Airworthiness Directive

| 81-74/2 Schleicher

| Schleicher ASW 19, all models,

| Schleicher ASW 20, all models,

| Aileron hinge

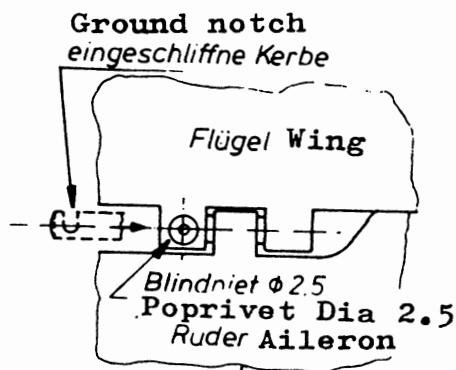
| It may be possible that the aileron hinge shaft
| is not correctly secured.

| Unless already accomplished, check the aileron hinges
| prior to next flight after publication of this AD to
| see, whether the pop rivet securing the aileron hinge
| shaft is in its place (see figure).
| The rivet head can be felt under the adhesive tape.
| If necessary, remove this tape to facilitate checking.
